Wisconsin Department of Transportation

Proposal #10:

1130-66-71, WISC 2027011
Appleton - De Pere
I-41 Mainline, Holland-CTH N
IH 41
Outagamie County

This is Addendum No. 01, which provides for the following:

PROJECT NO: 1130-66-71	HWY: IH 41	COUNTY: OUTAGAMIE	PERMANENT SIGNING	SHEET 274	E

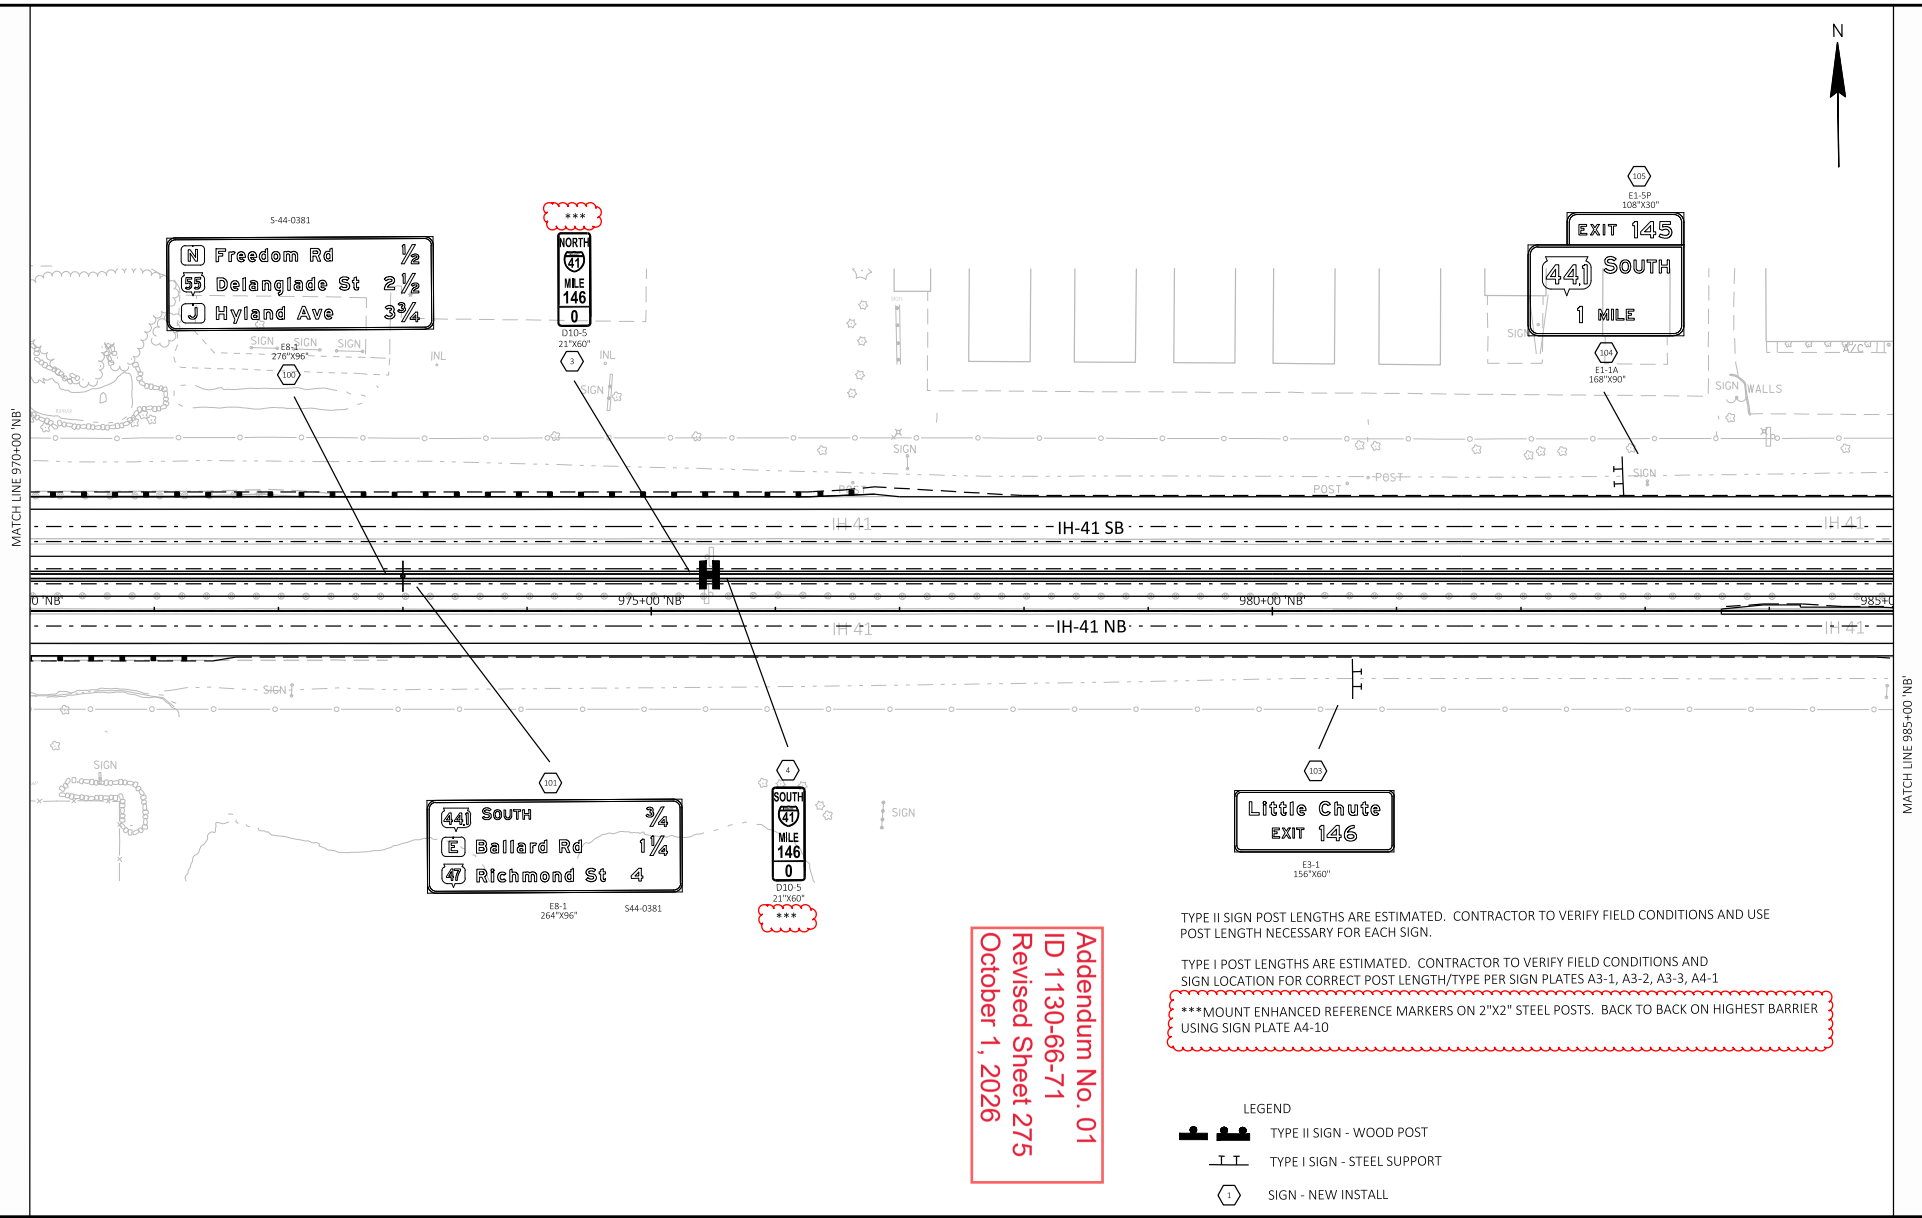
Revised Plan Sheets (1130-66-71)	
Plan Sheet	Plan Sheet Title (brief description of changes to sheet)
274-281	Permanent Signing (added note to mount Enhanced Reference Markers on 2”x2” steel posts)
329	Traffic Control General Notes (added note to indicate temporary ramp pavement structure)
437	Miscellaneous Quantities (added Excavation Common quantity for Relief Trenches)
438	Miscellaneous Quantities (revised Base Aggregate Dense 1 ¼-Inch, Select Crushed Material, and Geotextile Type SAS)
439	Miscellaneous Quantities (Revised Tack Coat quantity in the Asphaltic Items Table)
456	Miscellaneous Quantities (added notes to Type I signing table, moved Type II signing table to new sheet, Revised Type II signing table to include Posts Tubular Steel 2x2-Inch x 8-FT)

***MOUNT ENHANCED REFERENCE MARKERS ON 2"X2" STEEL POSTS. BACK TO BACK ON HIGHEST BARRIER USING SIGN PLATE A4-10

PROJECT NO: 1130-66-71	HWY: IH 41	COUNTY: OUTAGAMIE	PERMANENT SIGNING	SHEET 275	E

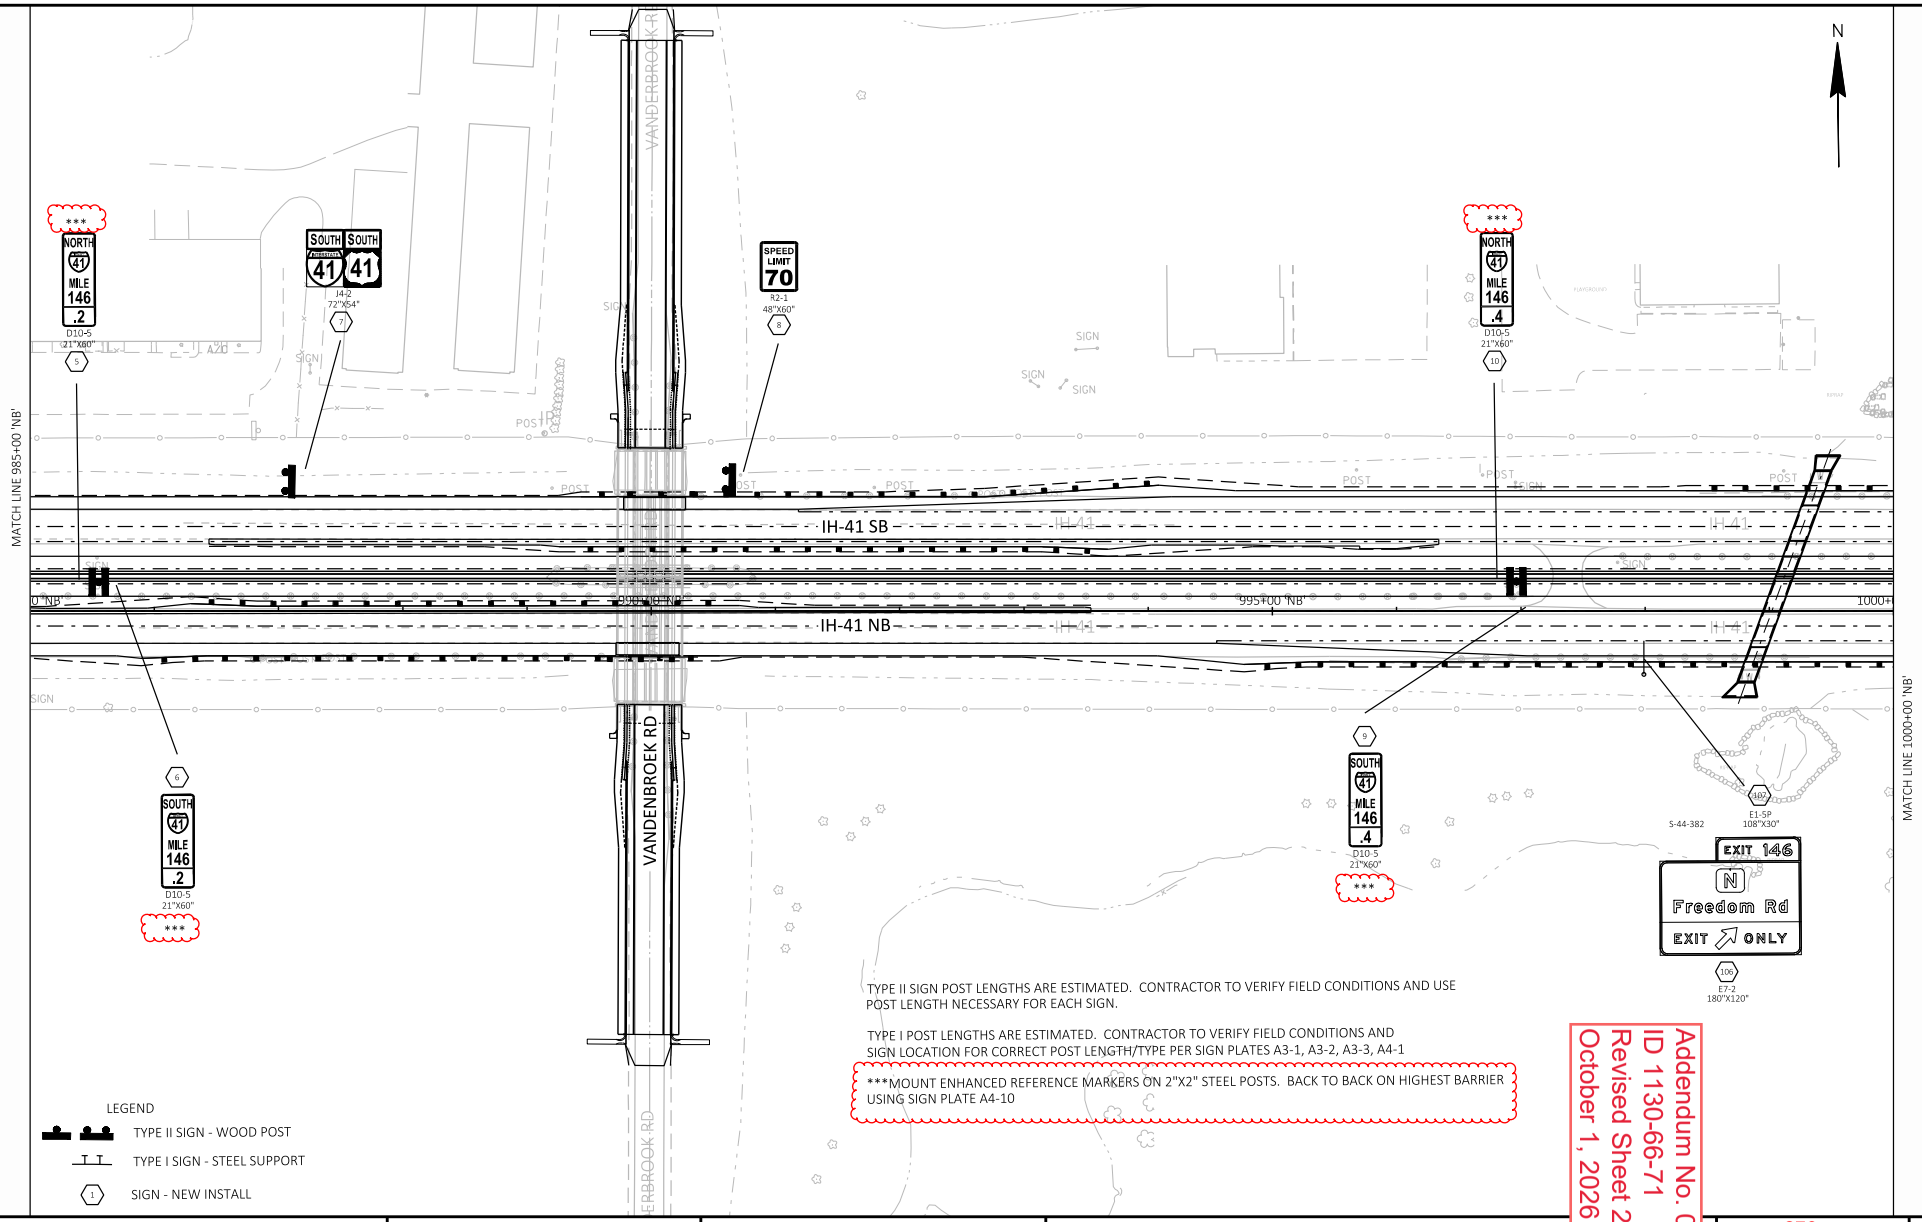
***MOUNT ENHANCED REFERENCE MARKERS ON 2"X2" STEEL POSTS. BACK TO BACK ON HIGHEST BARRIER USING SIGN PLATE A4-10

PROJECT NO: 1130-66-71	HWY: IH 41	COUNTY: OUTAGAMIE	PERMANENT SIGNING	SHEET 276	E

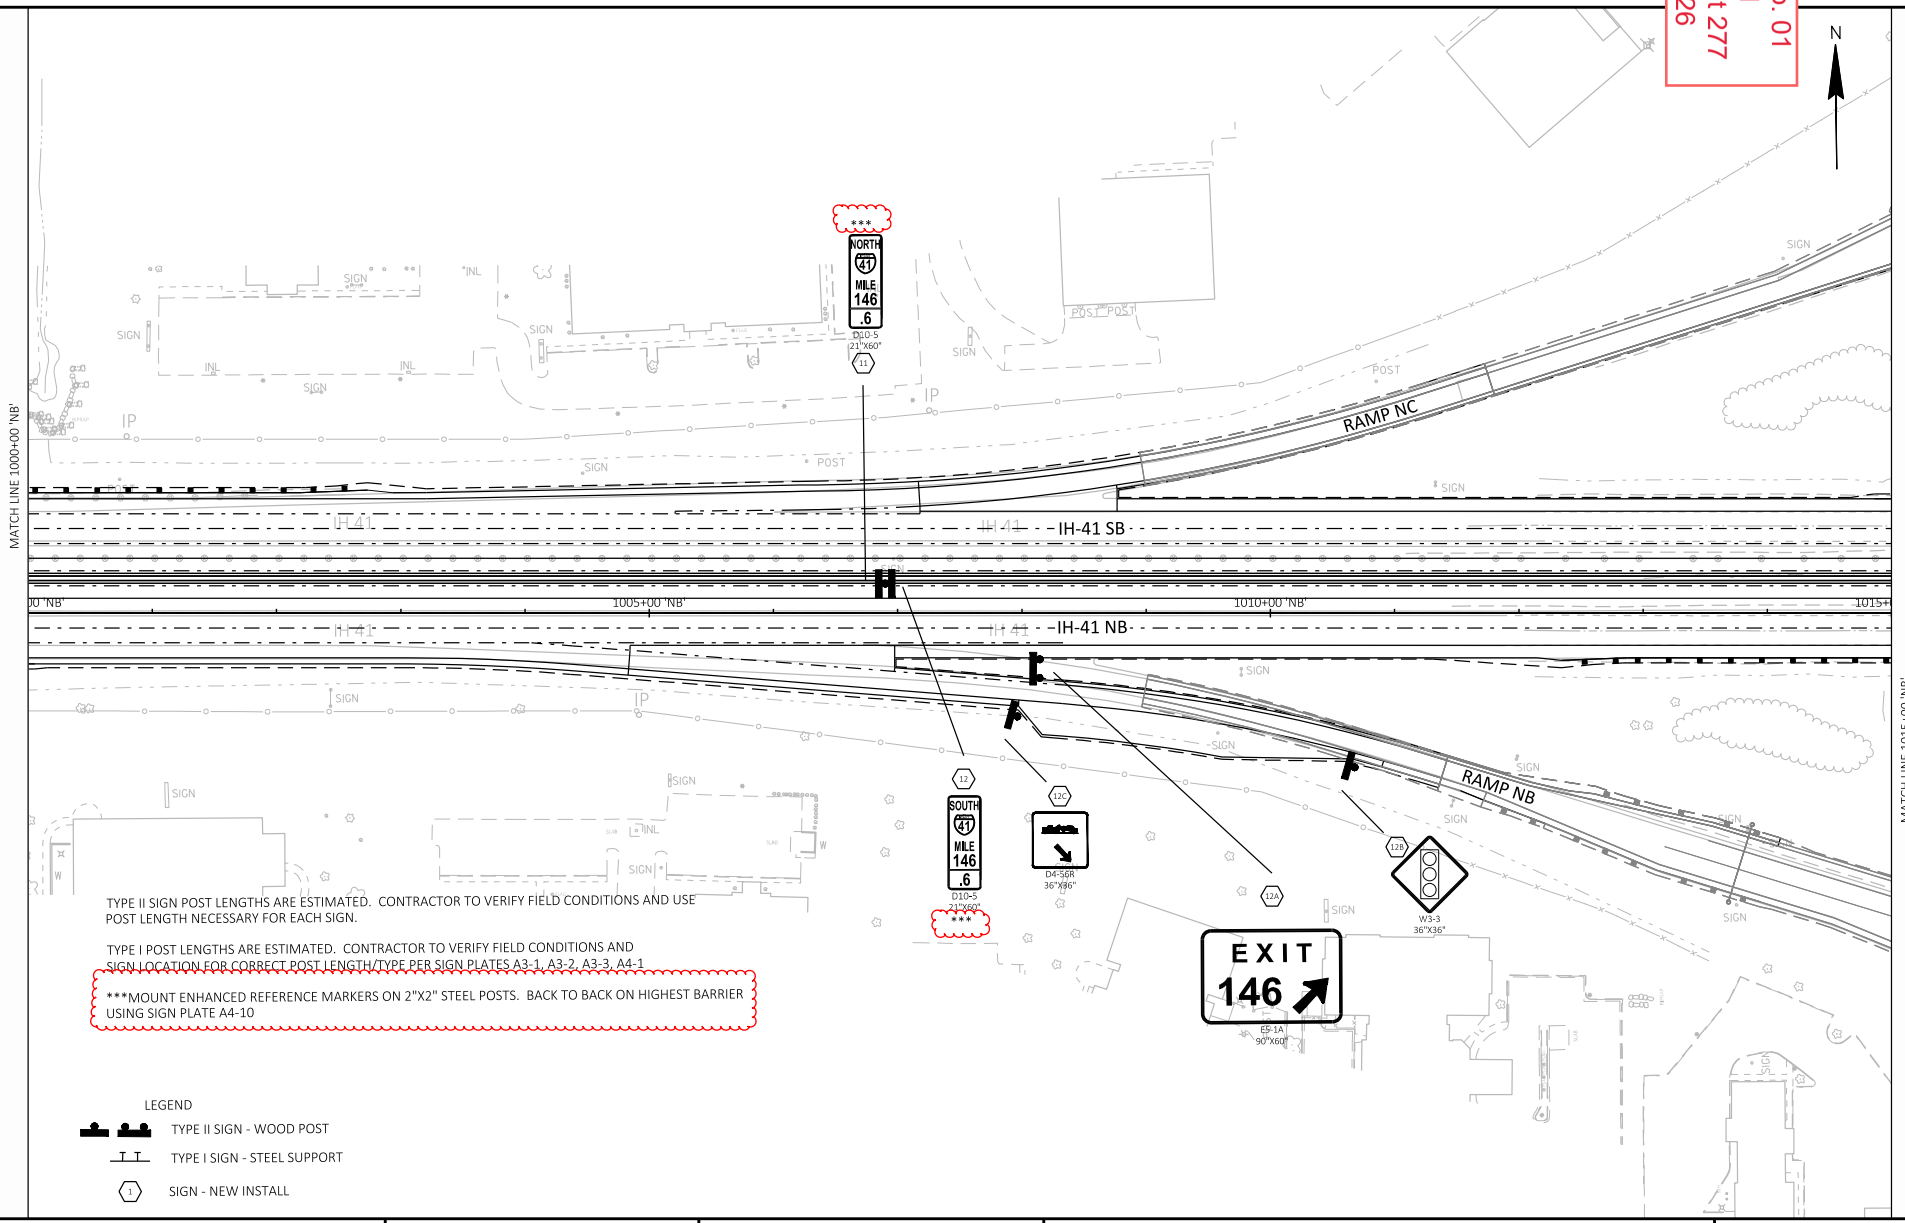
***MOUNT ENHANCED REFERENCE MARKERS ON 2"X2" STEEL POSTS. BACK TO BACK ON HIGHEST BARRIER USING SIGN PLATE A4-10

PROJECT NO: 1130-66-71	HWY: IH 41	COUNTY: OUTAGAMIE	PERMANENT SIGNING	SHEET 279	E

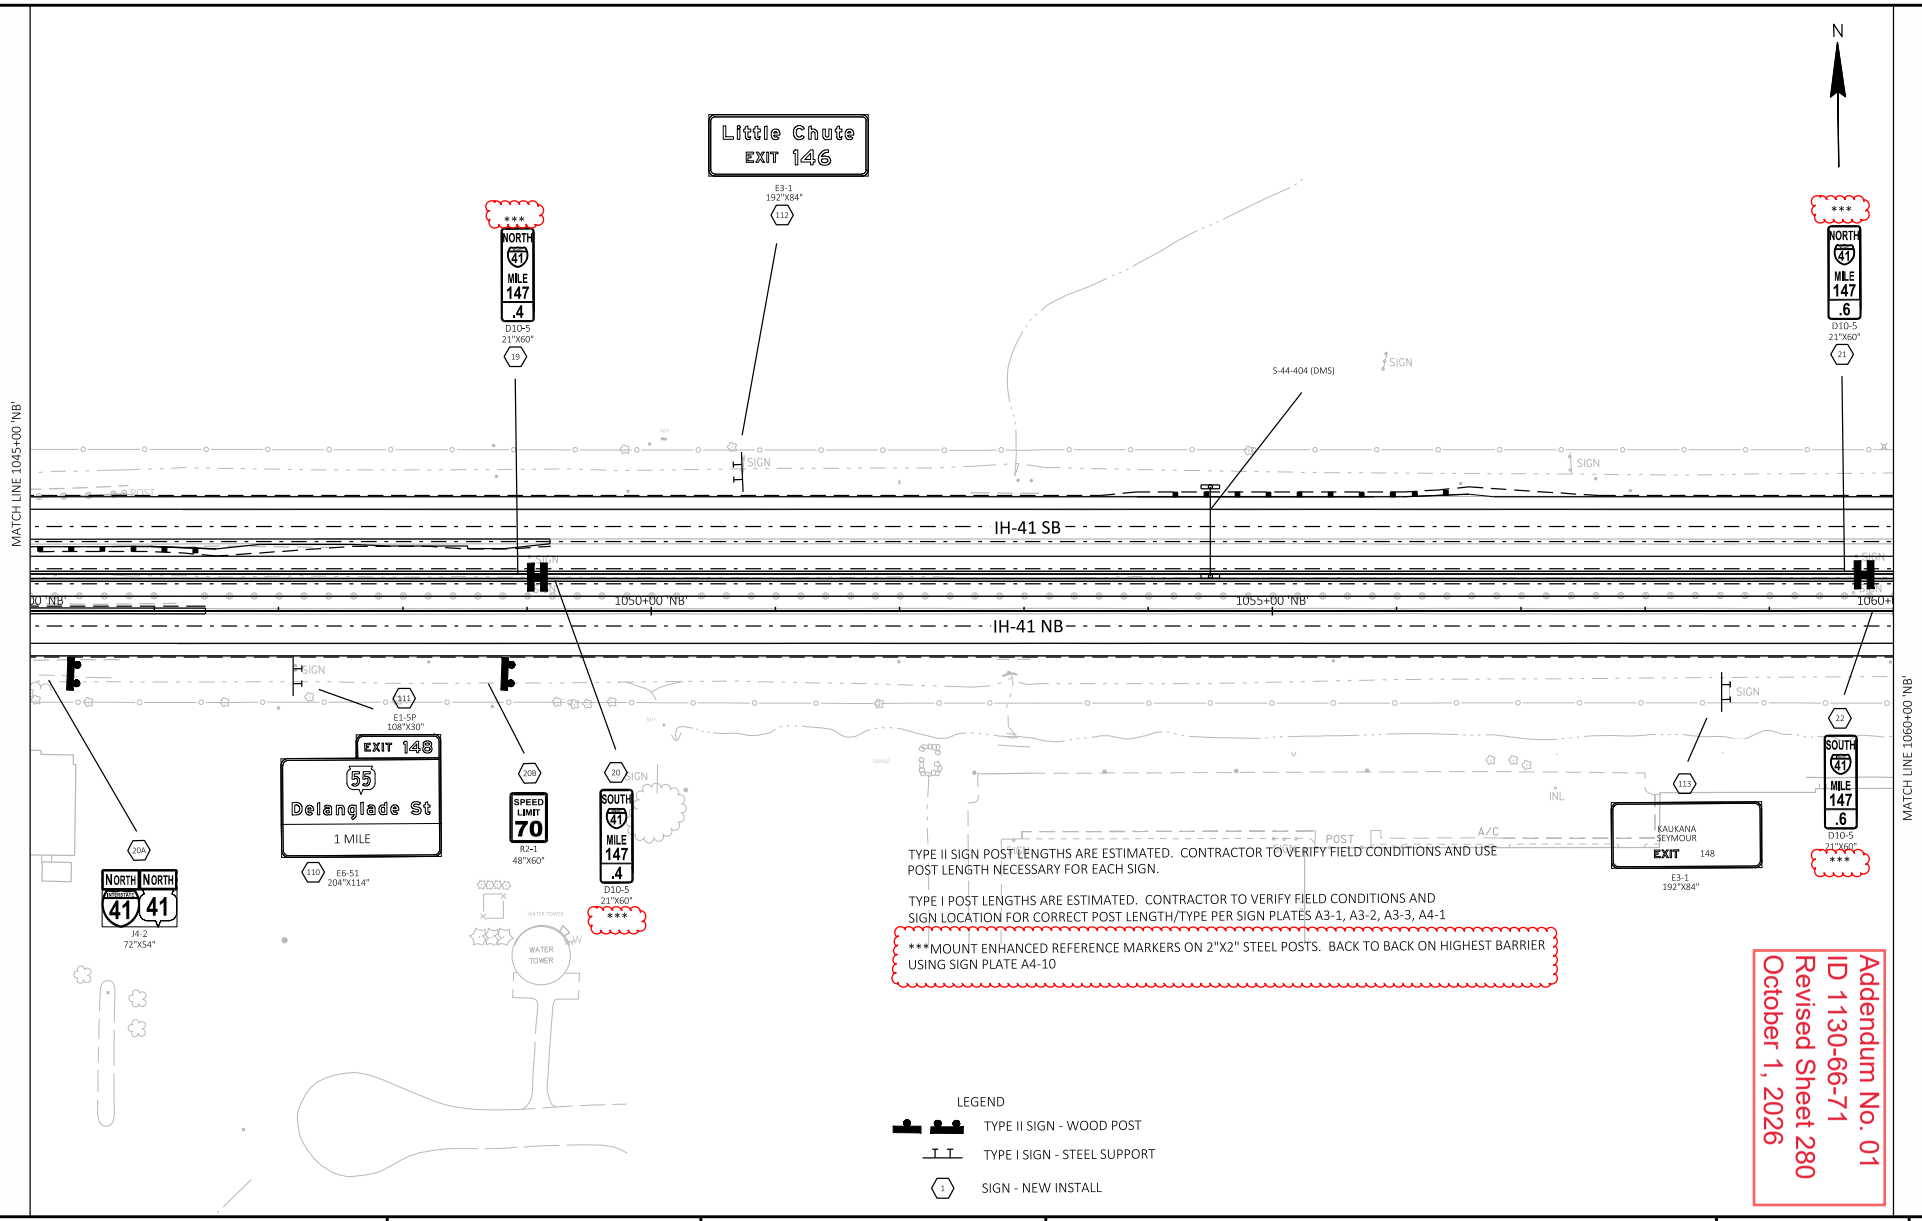
***MOUNT ENHANCED REFERENCE MARKERS ON 2"X2" STEEL POSTS. BACK TO BACK ON HIGHEST BARRIER USING SIGN PLATE A4-10
